Appendix 16.2

Atkins letter dated 21 December 2016 to EA

Planning application 322/16: Proposed extension to Linhay Hill Quarry
Your ref: DC/2016/118161/01-L01

In the meantime we wish to provide interim information regarding specific points listed in your letter dated 2 August 2016 ref DC/2016/118161/01-L01 page 3, on which the Agency requested clarity. Those points are listed under the section on 'Advice – Discharges to surface waters' and our clarifications are provided in the following pages.

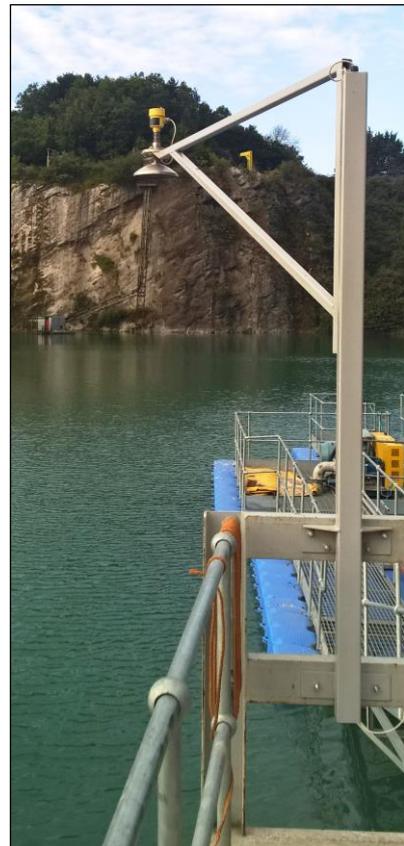
Response to Environment Agency question: How the level and discharge from the lake is controlled ?

The water level in the Balland Pit is continuously monitored by a Vega radar sensor mounted on a jetty as shown in this photograph. The jetty level is 82.884mOD and relative to a datum set at 6.35m to the water level from the sensor, the sensor currently has set points of:

UHL	Ultimate High Level	+0.75	83.63mOD
HL	High Level	+0.04	82.92mOD
Datum		6.35m	82.88mOD
LL	Low Level	-0.65	82.23mOD
ULL	Ultimate Low Level	-0.75	82.13mOD

There are currently no parameters configured relating to anything other than the water level. Pumping starts if the level of the pond goes above the HL set point. The Low Level Set point stops the pump to ensure there is always a suitable volume of water for settling.
